Product-information/change
Combi-lock

Product-information No. 01-281
Skejby, Date 18.12.2008

Cut-out for Combination Systems

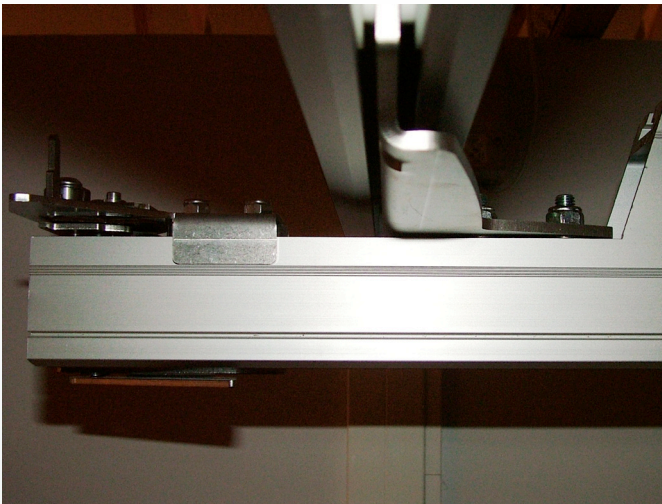
To minimize the deflection of the traverse rail in combination systems on the spot where the cut-out is made for safety lock, it has been decided to change the length of the cut-out from 310 mm. to 270 mm.

The short cut-out is 120 mm

To achieve the strongest installation, we recommend you to turn the trolley as shown.
